## Product/Process Change Notice (PCN)

PCN #: PCN\_ConCOM\_20180301

Product Affected: ConUSB31\_632723300011; 632723300021;  
632723100011; 632723100021PCN Date: February 8<sup>th</sup>, 2018

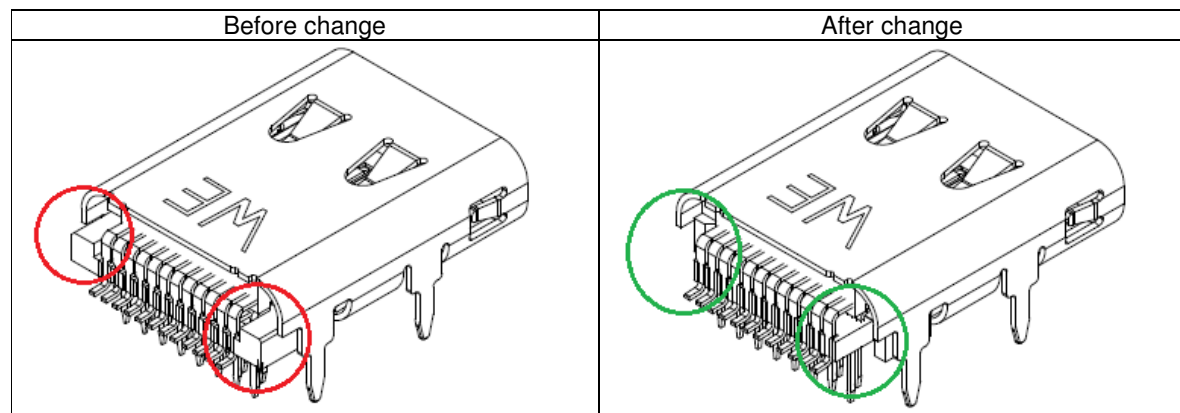
In order to enhance the product reliability, Würth Elektronik will change the housing design of these USB type C products and the manufacturing process.

Würth Elektronik reduces plastic housing size in order to facilitate mold extraction and improve processability.

This change has no impact on technical features (mating forces, insulation) of the product or connectors functional dimensions (layout, outer/overall dimensions).
